MEETING AGENDA
CITY PLAN COMMISSION
Wednesday, May 11, 2022
Work Session 9:00 a.m.
Public Hearing: 10:00 a.m.

D. *DEVELOPMENT REVIEW COMMITTEE (DRC) COMMENTS*

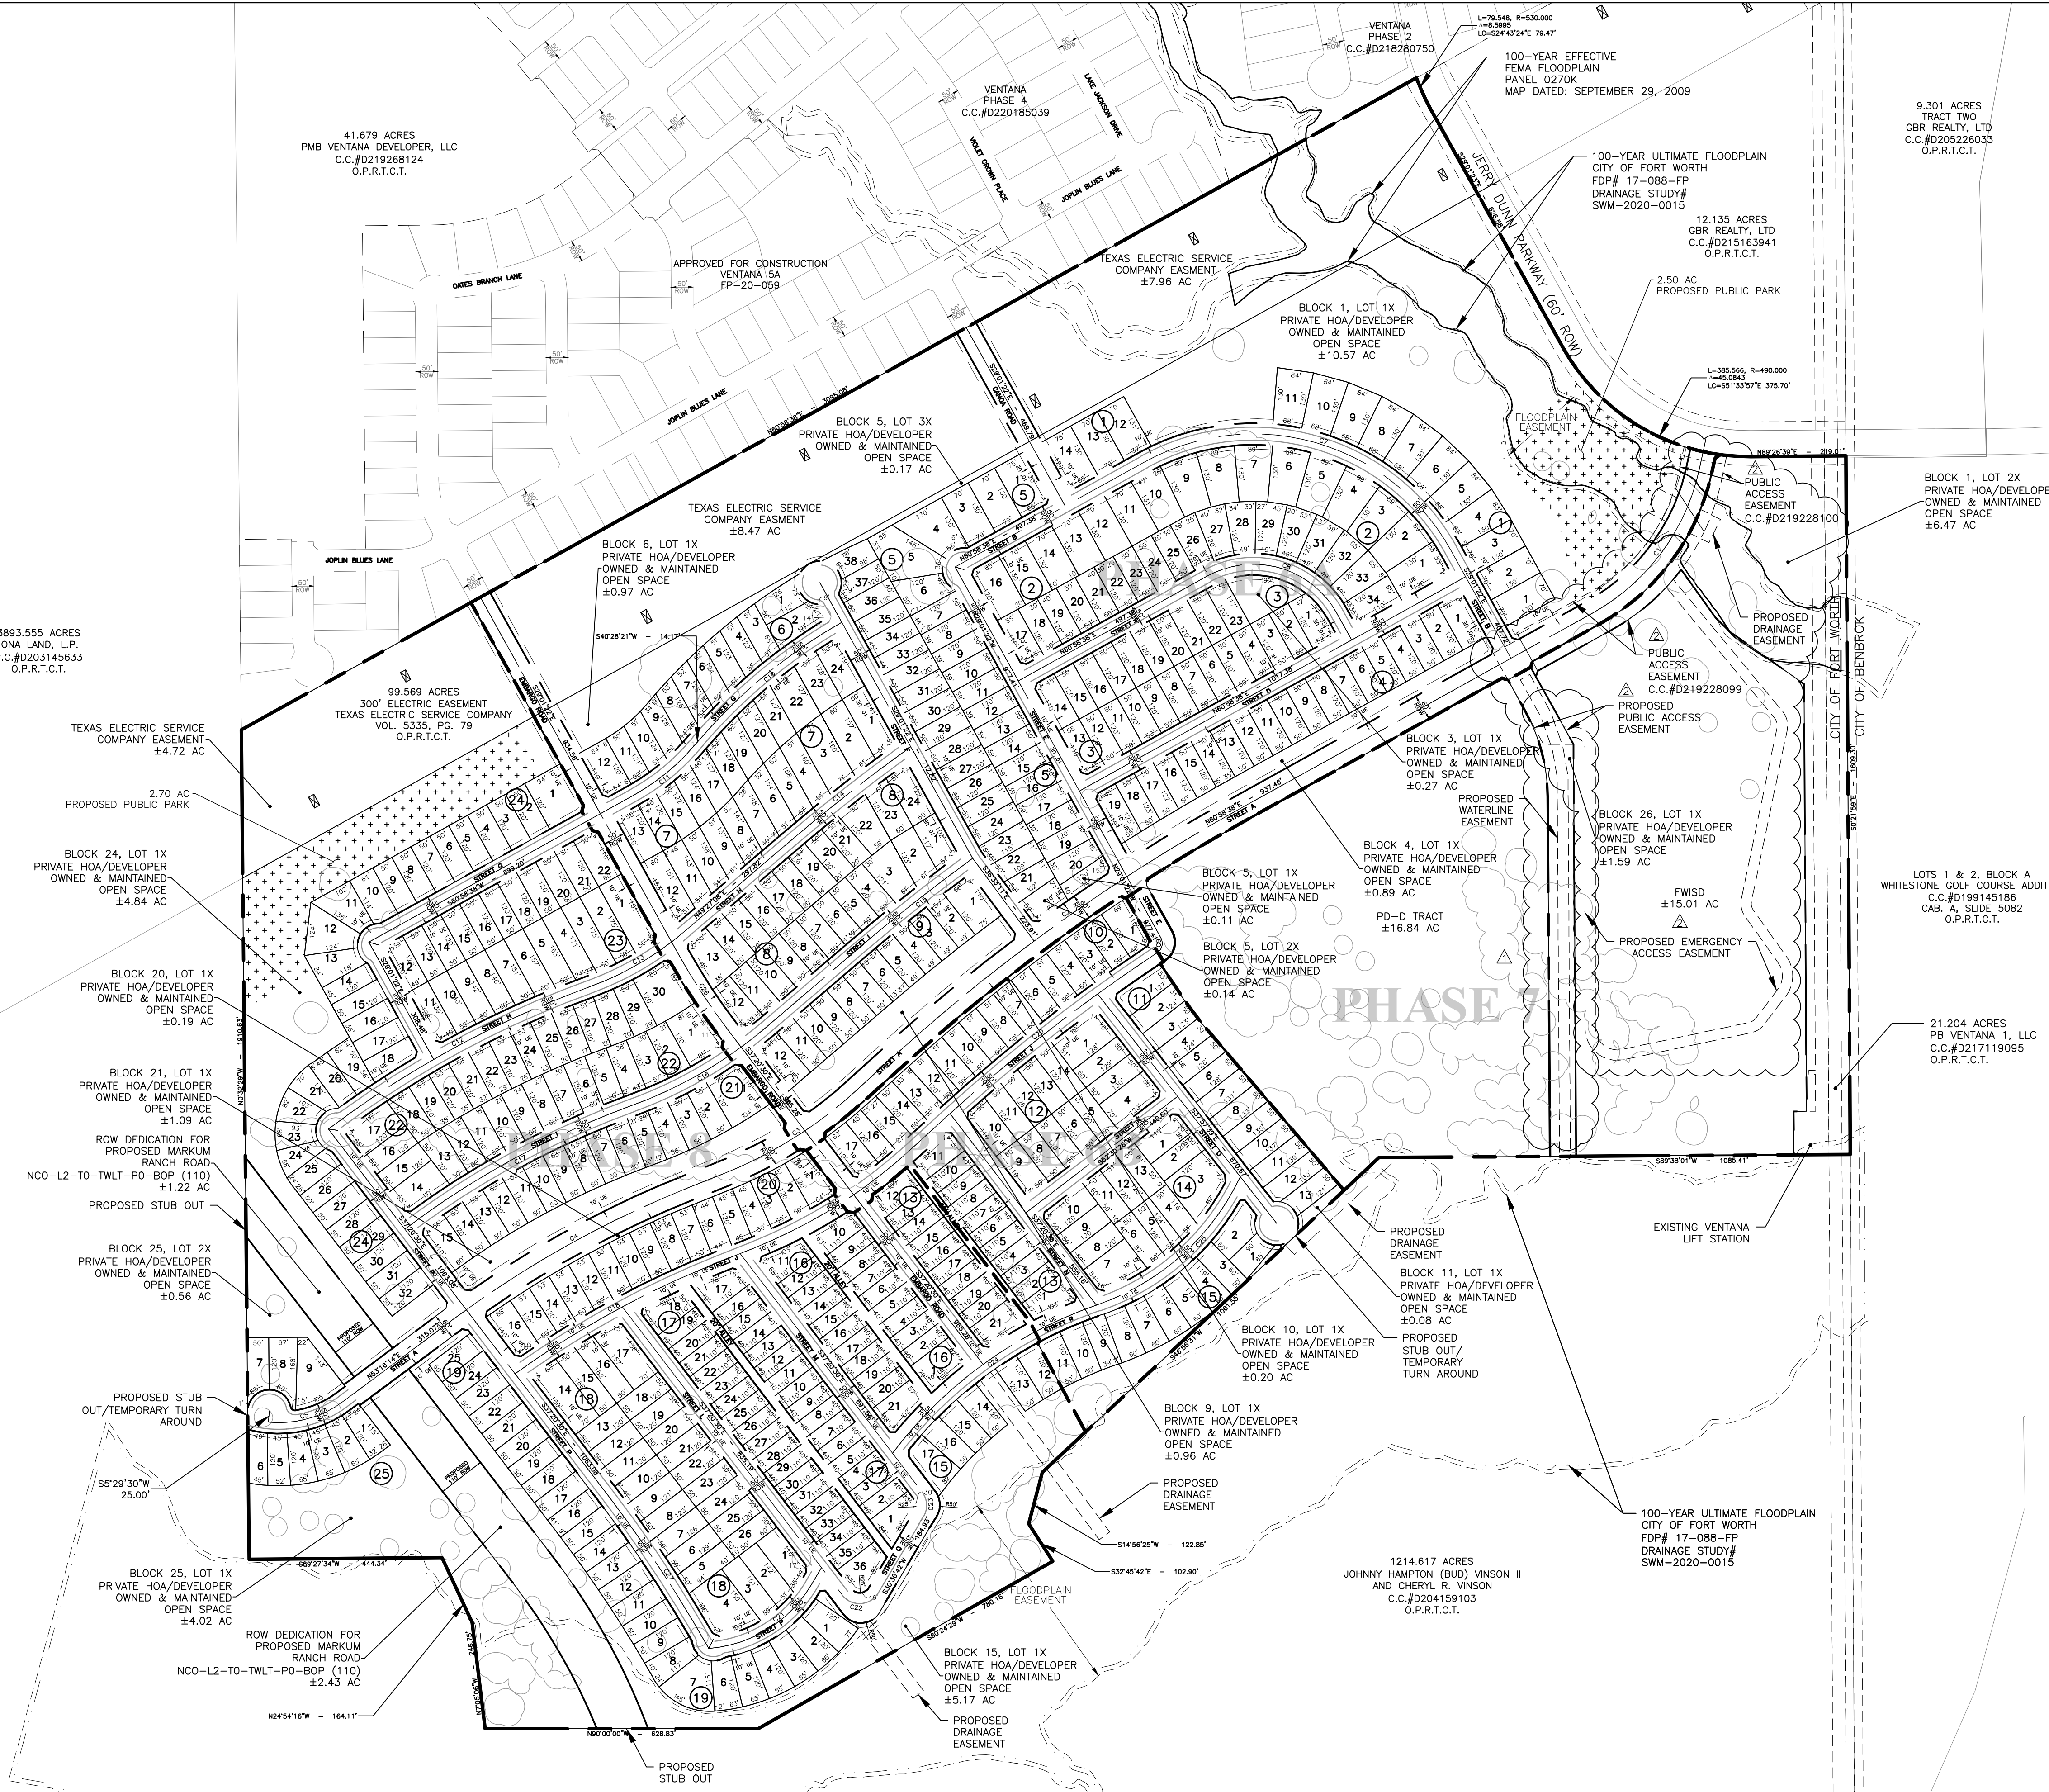
PARD/PDP: The Neighborhood and Community Park Dedication Policy applies. Neighborhood Parkland dedication is REQUIRED, minimum of 5.1383 acres of which 25% must be out of the floodplain. Additionally, park to be located in such a manner that there is no more than a 10 minute walk (1/3 mile radius) from within the development. Park location and concept plan must be agreed to before Preliminary Plat can be approved by Plan Commission. Community Park F-I-L is required for this plat.

CLEARED 02/25/2021 1. A site plan is required for multi-family developments. Email a site plan for Fire Code application to donna.york@fortworthtexas.gov. The site plan must show that emergency access easements are at least 26 feet wide and provide access to all exterior portions of all buildings within 150 feet in a 5 foot wide unobstructed path. The distance can be increased to 300 feet if the building is equipped with a fire sprinkler system. Vehicle access gates must be shown to be a minimum of 20 feet wide when fully opened. Show fire hydrants and the location of any fire department connections for sprinkler systems or standpipes. If a site plan is not available, indicate the area where the multi-family development will be located on this plat.

The Subdivision Ordinance, Section 31-81 (2) a. states each subdivision of land shall provide adequate public facilities including water, wastewater collection and disposal, drainage facilities, parks and recreation facilities, and transportation facilities necessary to properly serve the proposed development, including related off-site facilities. Provide the status of the 15,000 gallon water tank. DRC recommends conditional approval of the final plat (Phases 3A & %) conditional upon a second 15,000 hydro-pneumatic tank being installed by the developer and accepted by the City. CLEARED 3/9/21 DSC.

The proposed preliminary plat will require a waiver for stubouts. Subdivision Ordinance, Section 31-106(c)(7)(a) requires that local streets shall be extended to the subdivision boundary to connect with adjoining streets or with adjoining unplatted property. The unplatted tract to the south and west are unplatted. A project redesign or CPC waiver requests is required. CLEARED 3/9/21 DSC. REVISED PRELIMINARY PLAT.

2. Show the dimensions of all existing or recorded streets, alleys, easements, railroad ROW, or other public ROW within or adjacent to the subdivision boundaries. The distance from the centerline of the existing roadway of the boundary street to the proposed property line shall be shown. Include all dedication information for all existing rights-of-way. CLEARED 04/29/2022 AB.

Remove (UE) Utility Easements should read as follows: Water Exclusive Easement, Sanitary Sewer Exclusive Easement, or Water and Sanitary Sewer Exclusive Easement. Please revise the proposed plat to provide the adequate easement minimum 15 feet, 7.5 foot on each side of pipe.

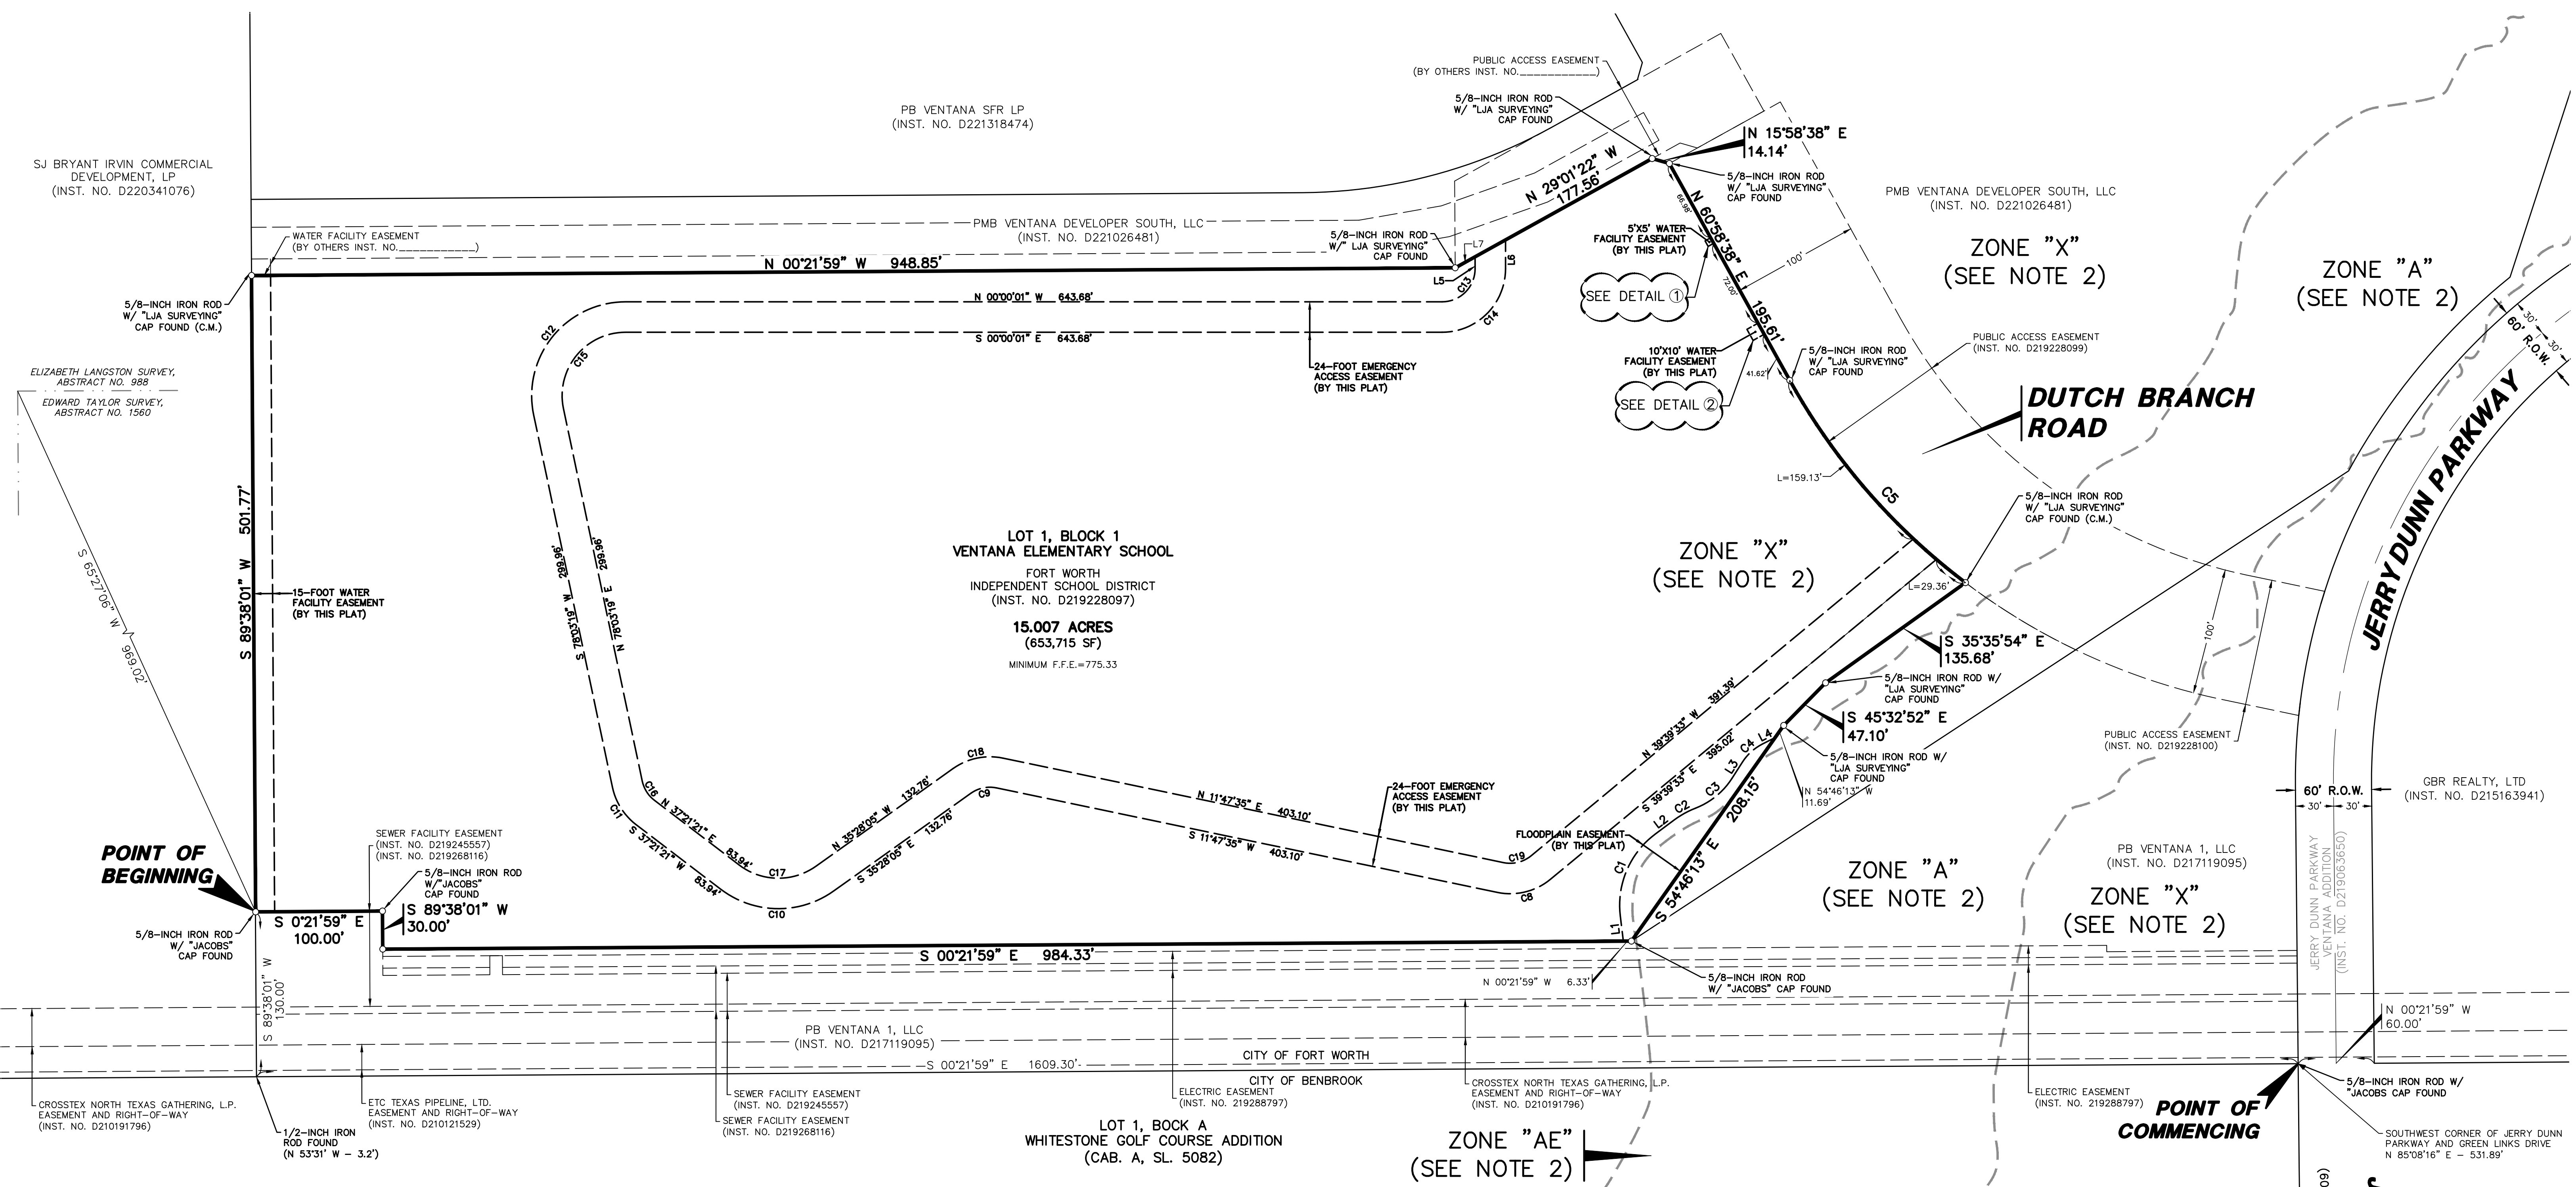
2. Right-of-Way: Ensure required dedications to adjacent right-of-way, including corner clips, are shown on the plat. Required street sizing for use types may be found in the Master Thoroughfare Plan. The minimum width for an urban local cross section is 50 feet. [SO, Sec. 31-106] NOT CLEARED LM. SUBJET PROPERTY DOES NOT HAVE ACESS. NO ROW HAS BEEN DEDICATED.

8. Easements: Show, and label, the locations and dimension of easements for water, sanitary sewer, utility and storm sewer utilities. For lots adjacent to or containing 100-year floodplain/floodway and drainage easements, label minimum finish floor elevation. Easements should be indicated with a dotted or dashed line. Abandonments may be indicated by stipple or crosshatch shading NOT CLEARED

3- CLEARED MJP 04/20/2022 - MJP 03/28/2022 - Water extension along western property line is required. Provide 1" Water connection to the lift station site

4- HOLD - MJP 03/28/2022 - Provide easement for the 24" Water main along western property line.
